# UNITED STATES PATENT AND TRADEMARK OFFICE

APPLICATION NO.	FILING DATE	FIRST NAMED INVENTOR	ATTORNEY DOCKET NO.	CONFIRMATION NO.
10/706,661	11/12/2003	Timothy Allen	81074236	7278

## Office Action Summary

**DETAILED ACTION*****Drawings***

Figure 2A

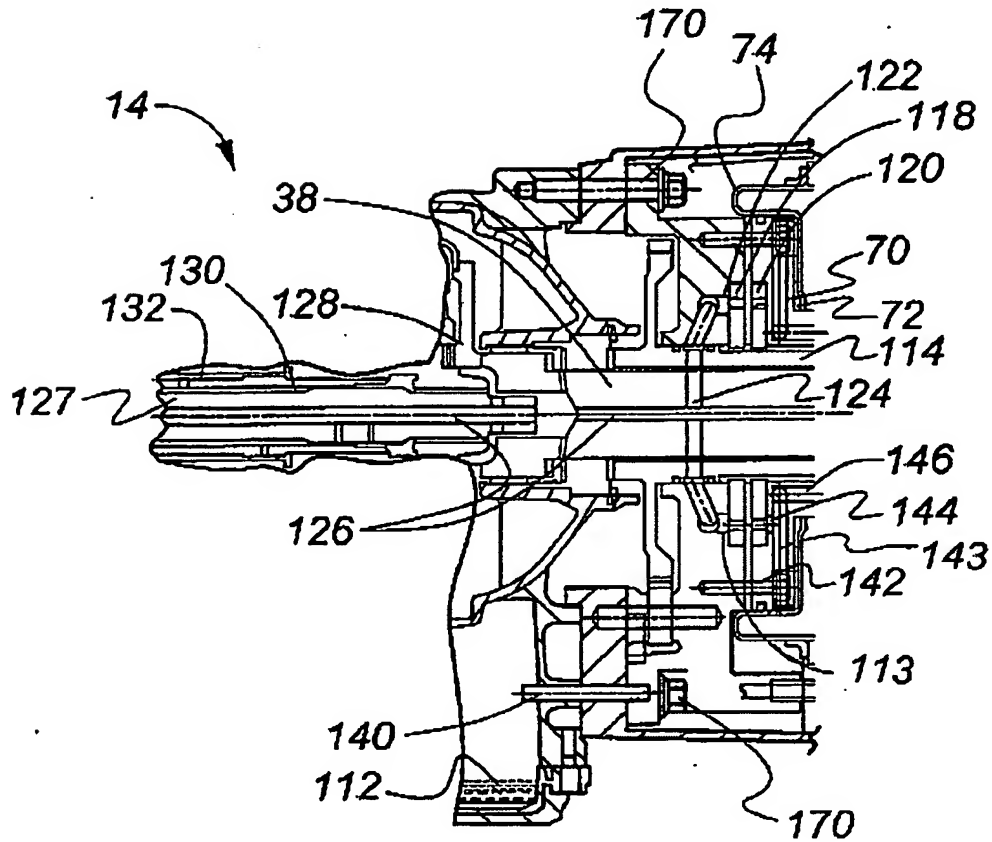
1. The drawings were received on Oct 31, 2006. These drawings are not approved for containing a new matter. The sump 110 having the inlet 113 as newly included in Figure 2A is considered a new matter since the Specification and the Drawings as originally filed fail to show or even suggest that the passage 113 is the inlet for the sump 110 as shown in Fig. 2B.

not approved on 12/12/06

**Figure 2B**

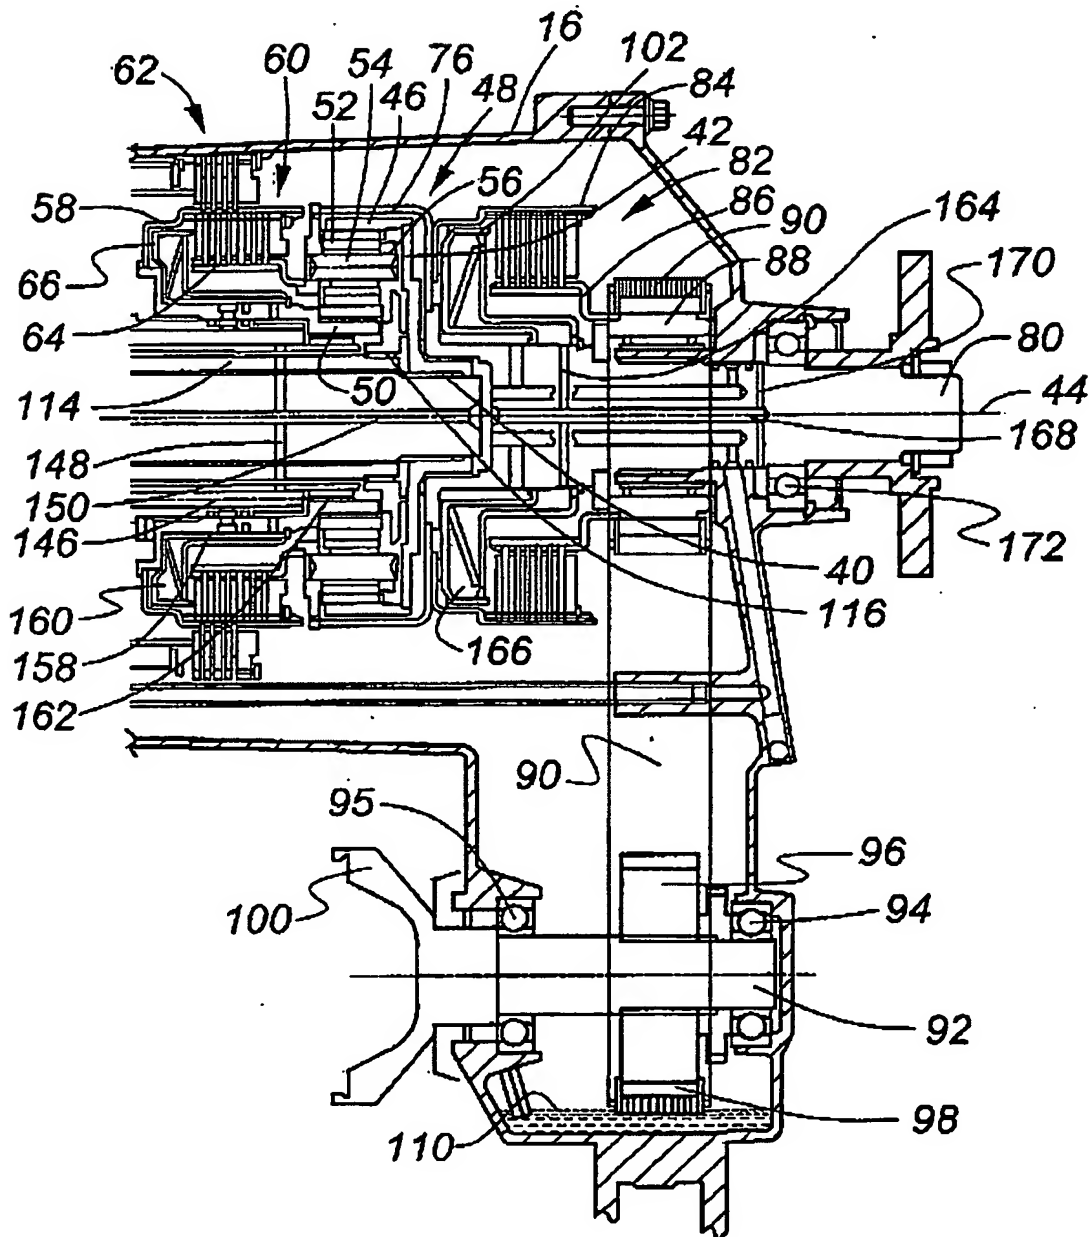
Not approved on 12/12/06
